PROJECT
RYLANDS BUILDING, MANCHESTER

TITLE
COMPARISON PLAN SIXTH FLOOR

JOB No	DWG No	REV
1526	AL[05]4219	*

ISSUE FOR
PLANNING DOCUMENT

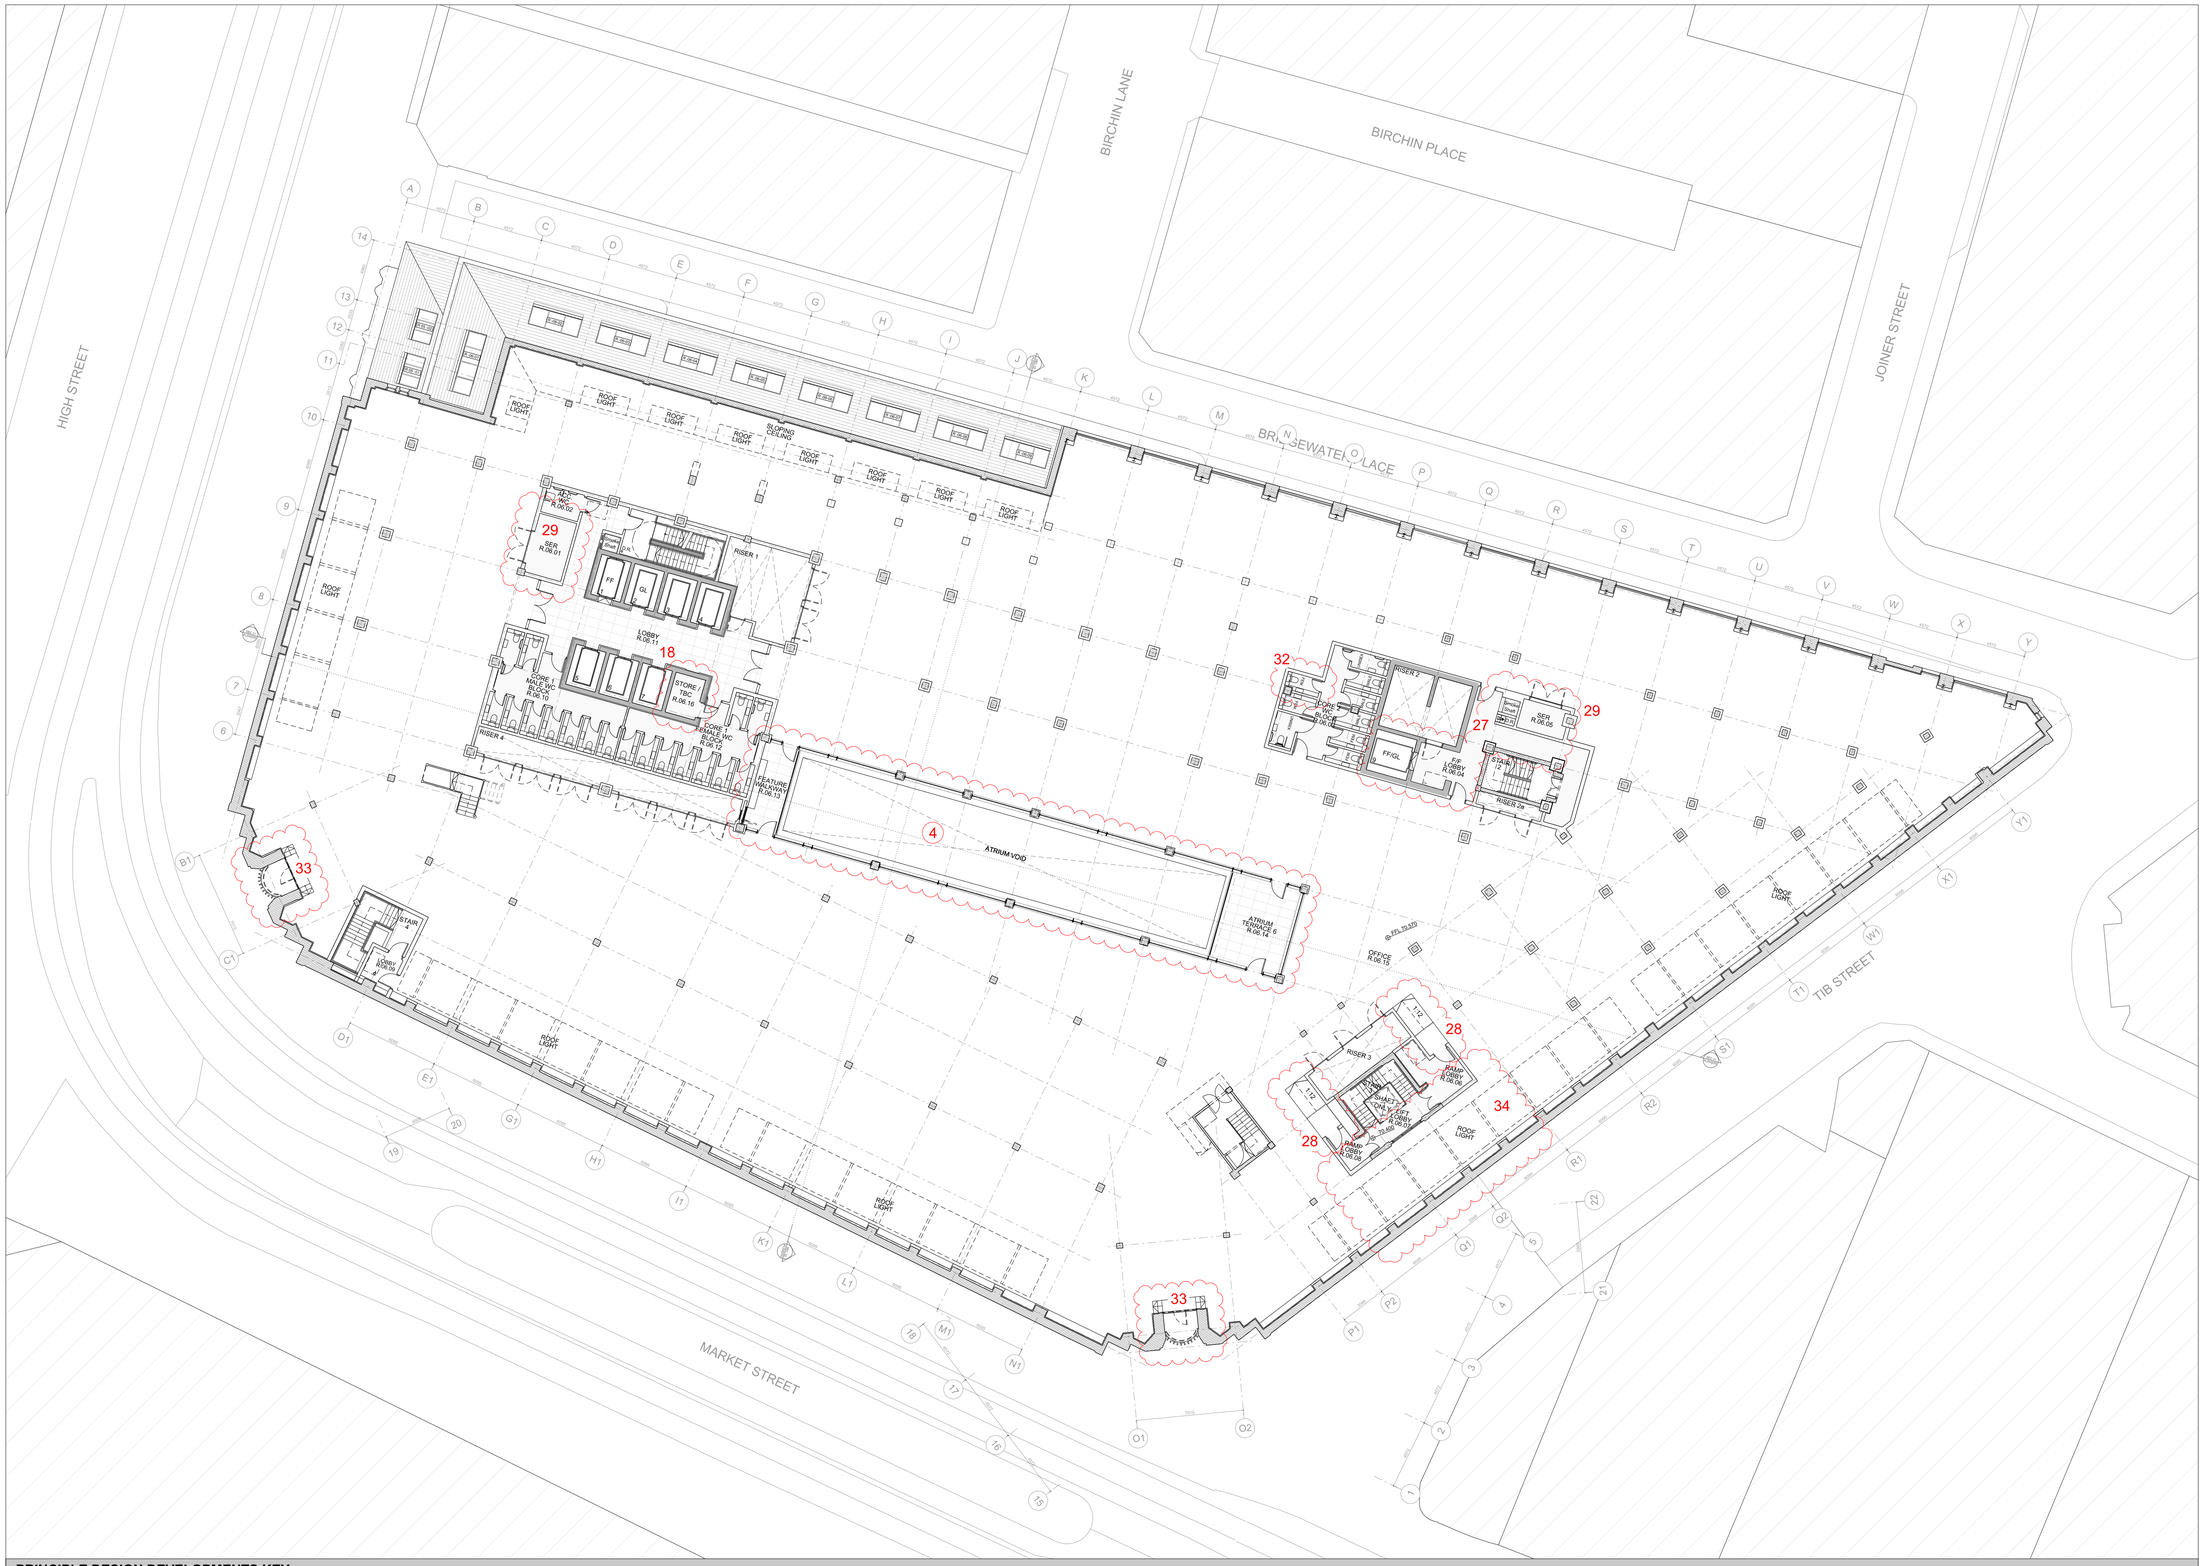
PRINCIPLE DESIGN DEVELOPMENTS KEY

1. Double-mullions & Parallel Opening Vents omitted from extension elevations
2. Saw-tooth roof profiles reduced in number & length. Sawtooth structures to carry PV panels only, thermal envelope now at roof slab level.

3. Core 2 lift overrun height lowered within Roof Plant enclosure due to VRF MEP strategy.
4. Glazing sections to Atrium simplified.
5. Terrace 7A omitted. New back-painted glass screen to accommodate new VRF MEP servicing strategy at existing roof level. PPC vent louvres to lid, & to base of West elev, concealed behind main stone parapet.

6. New Market Hall Unit & revised Office Foyer at Ground Floor Level
7. Lower floors replanned (see notes on General Arrangement plan drawings).
8. Overall height remains unchanged from the consented scheme.

9. Roof-plant enclosure reduced in width & lengthened to GL. H to accom. VRF MEP strategy. PPC vent louvres to base of South & North elevs concealed by sawtooths.

10. Double-mullions omitted from Shop-front glazing
11. New fire exits required to Shopfronts for Market Hall use
12. New Market Hall entrance door arrangements

13. Updated Cycle-store entrance and exit arrangements
14. Back-painted glass in glazed facade system to match main facade system - Profiled metal cladding omitted.

15. Lift overrun wall widened to conceal adjacent plant.
16. Protected Lobby update.
17. Store area adjusted.
18. Lift 8 omitted. Void/Store/tbc
19. Drop shaft relocated.

20. Facilities Management & General Back of House areas updated to accommodate Market Hall.
21. Plant and bin store arrangement updated to accommodate Market Hall.

22. Lobby arrangement to increase locker provision within changing
23. Cycle lift & ramp omitted for new cycle-stair, reducing structural impact
24. Continuity of EXTG Floor area (hatched) subject to investigation - possibly ground bearing slab at high level

25. Updated lobby & stair entrance preserving more of existing building fabric.
26. Lobby arrangement to increase in area.
27. Core 2 Lift functions & service levels rationalised for efficiency

28. Ramp external to Stair 3 lobby
29. Equipment Room provided.
30. Rooflights rationalised into singular rooflight
31. Cleaning facilities provision updated.

32. WC added.
33. Extg balconies refurbed for reuse.
34. Winter Garden omitted.
35. External fabric amendment to accommodate existing structure.
36. Existing doorway retained, new door fitted to match new adjacent.

37. Security bollards to Bridgewater Place entrance.
38. Bird & batbox proposed locations included.
39. Partition line moved to increase commercial space.

40. Green roof to flat roof of L7 link.
41. Ducting terminations in aesthetically coordinated metal sheathing.
42. Renewables omitted @ L7 roof.
43. Horizontal plant-screen fins omitted.

44. Overrun of Lift 10 removed.
